Meeting Date: June 21, 2022

Hearing Body: Planning and Zoning Commission

Project Summary: **Zone Change to permit construction of a parking lot and conversion of existing single-family house into multi-family units for employee housing and an office**

PZ21-00016 (ZC) Planning Comments

35 Inspirational Parking Plan

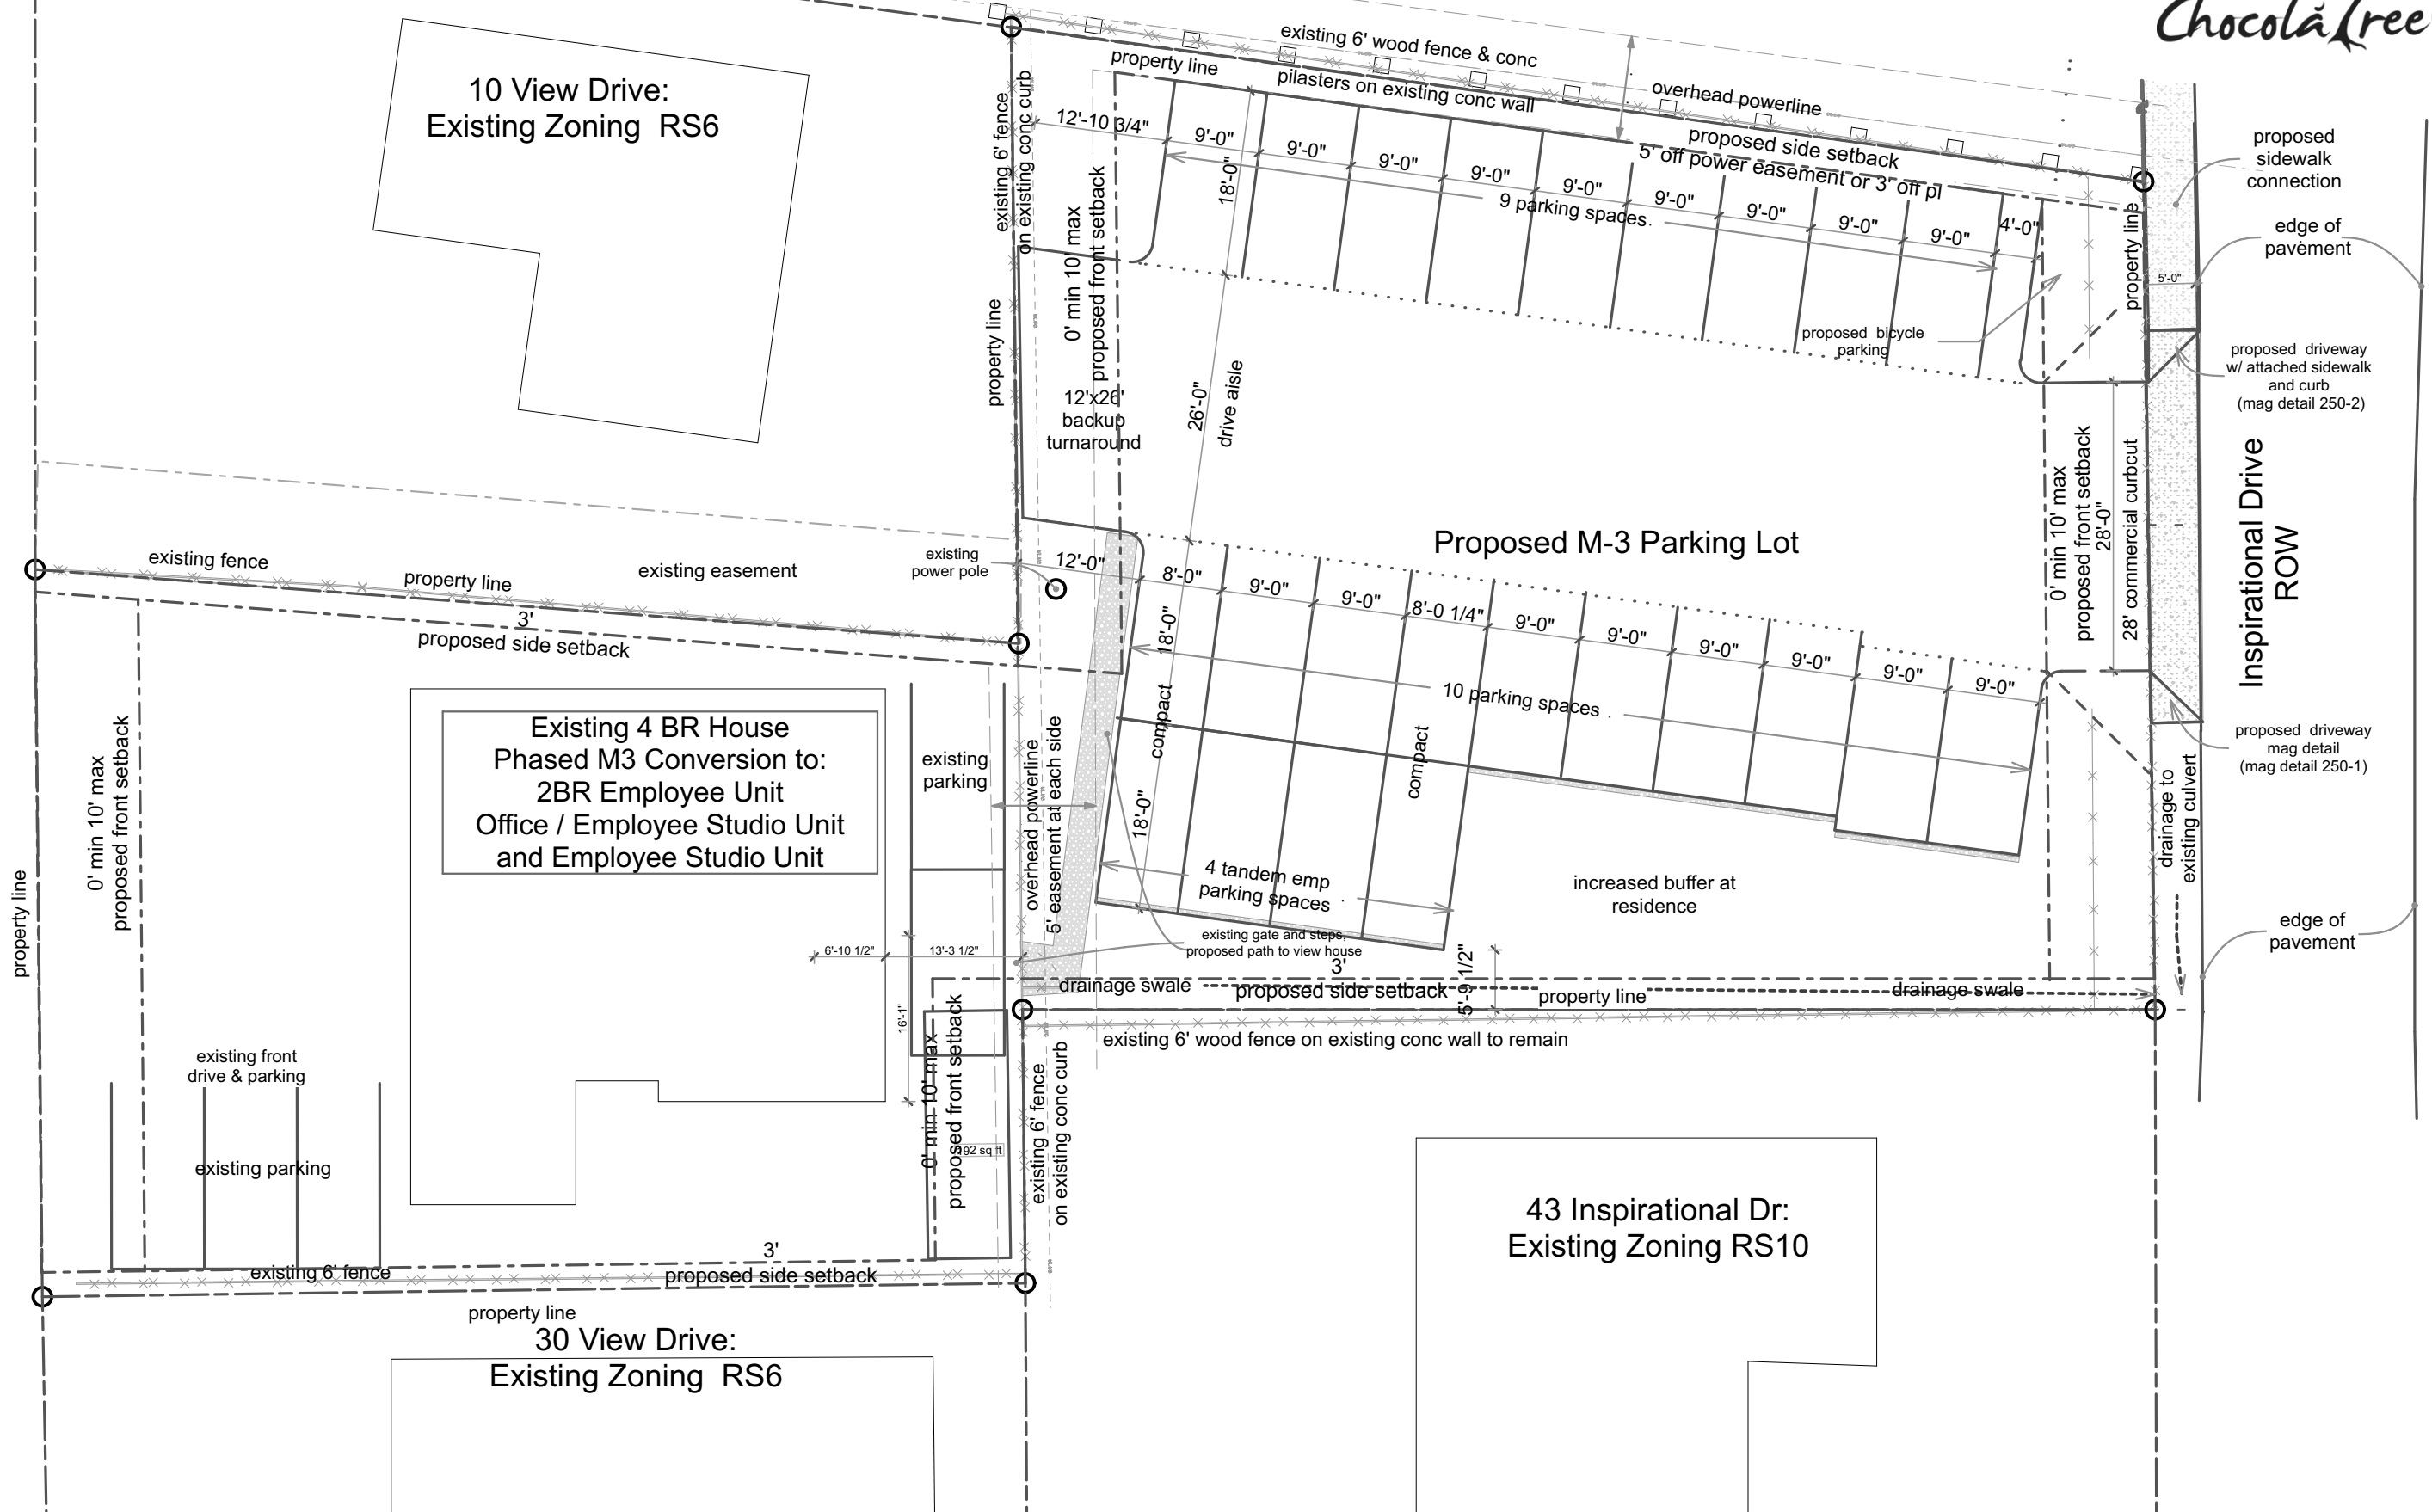
8. Site Plan
 - a) A sidewalk along the street frontage is required – show sidewalk on plans.
 - i) For the parking lot to be used as off-site parking for Chocolatree, there must be a connection along a legal pedestrian route. Show sidewalk connection from the frontage of this lot to

sidewalk along W State Route 89A. (LDC Section 5.5.E(2)a). If this connection does not currently exist, add to plans/scope of work.

- b) Plans show a gate along the Inspirational Drive side of the property. Gates are required to be located to allow a car to wait on the property (without blocking streets and sidewalks) while the gate opens. The gate is shown about 10 feet off of the property line, which is not enough depth for a car. Relocate or remove gate. (LDC Section 5.5.G(3))

- c) Indicate location of bicycle parking. (LDC Section 5.5.D(3)c).
 - d) Show path of travel and calculate length from proposed parking lot to Chocolatree.

- e) Show Inspirational Drive pavement surface on site plans; include distance from pavement to property line.
 - f) Include a pedestrian pathway from the existing house to the proposed parking lot.

1. A sidewalk connection along Inspirational Dr. is required. Please show a 5' sidewalk from the southerly property line of the proposed parking lot to connect to the sidewalk at 89A; approximately 235ft.

6. Delineate the public utility easement on the plans.
7. Include a drainage swale at the southerly property boundary to direct any runoff towards the roadside ditches.

- a. The connector sidewalk is shown in drawing “8.a d Pedestrian access plan.pdf”
 - b. There will not be gate at the entry to the Inspirational Drive side of the property.

- c. The bicycle parking is on “8.c e f. P-1 Inspirational Parking Plan.pdf”
 - d. Pedestrian Travel Path is shown on: “8.a d Pedestrian access plan.pdf”

- e. Edge of pavement is shown on “8.c e f. P-1 Inspirational Parking Plan.pdf”
 - f. Pedestrian path is shown on “8.c e f. P-1 Inspirational Parking Plan.pdf”

6. Delineate the public utility easement on the plans. Shown on:, "8.c e f. P-1 Inspirational Parking Plan.pdf"
7. Include a drainage swale at the southerly property boundary to direct any runoff towards the roadside ditches. shown on "8.c e f. P-1 Inspirational Parking Plan.pdf"
